**City of Richmond**  
Planning and Development Department

**Report to Committee**

**File:** RZ 08-408104

**Re:** Application by Polygon Development 222 Ltd. for Rezoning at 9420, 9460, 9480, 9500 Odlin Road from Single-Family Housing District, Subdivision Area (R1/F) to Comprehensive Development District (CD/201)

1 NORTH ELEVATION - BUILDING 1A & 1B  
SCALE 3/32" = 1'-0"

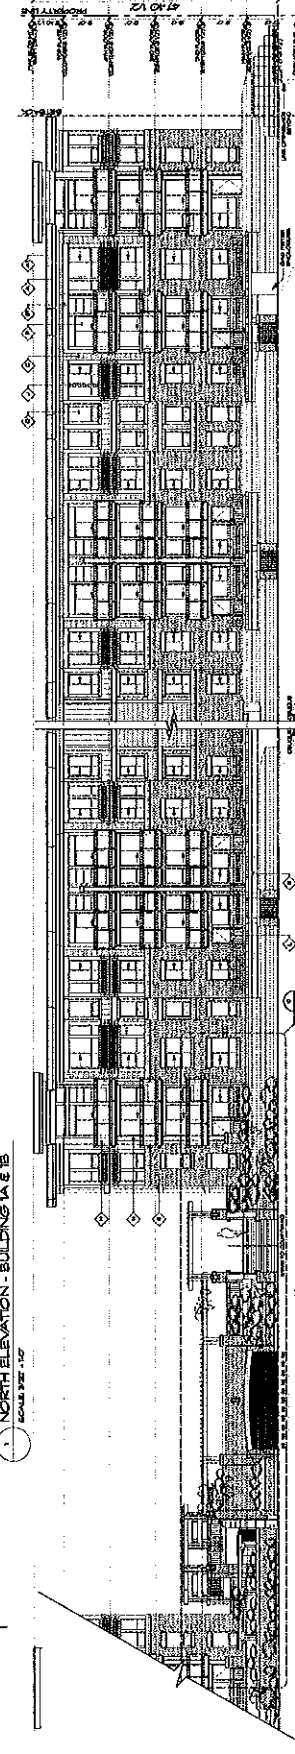
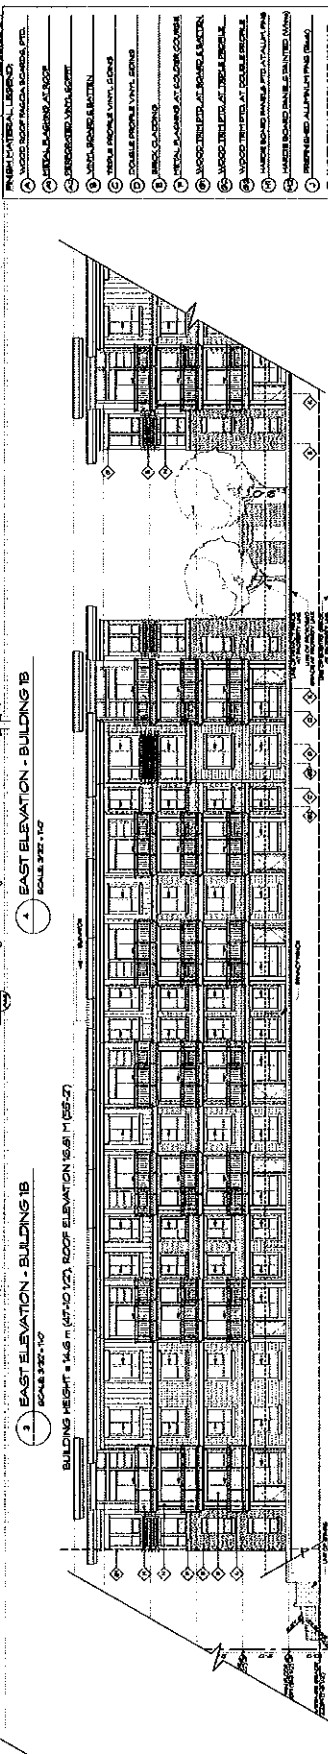
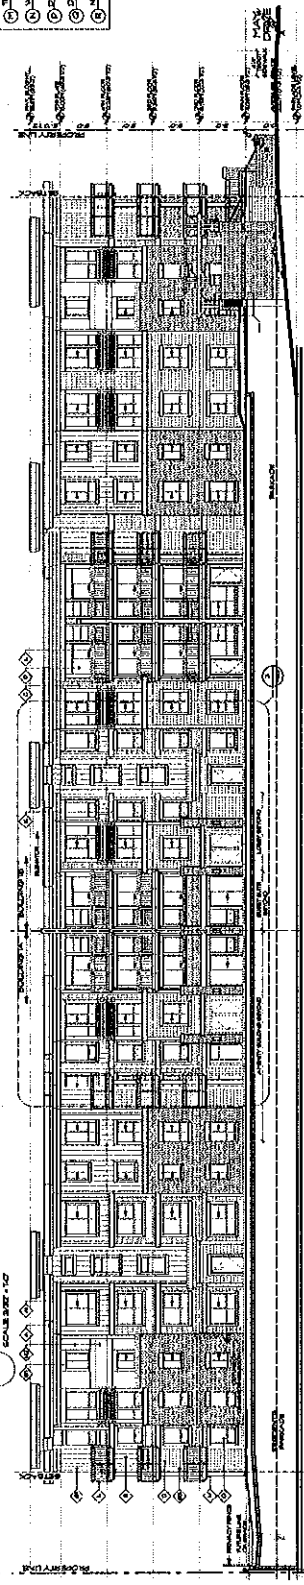
**12. *consider adding contrast in colour or material changes to the areas around the entries to add punch to the entry areas;***

See attached elevations. Framing for the full height glazing has been changed to black to give higher impact and better differentiate the lobby. The entry area has been improved with increased detail and visibility of lobby.
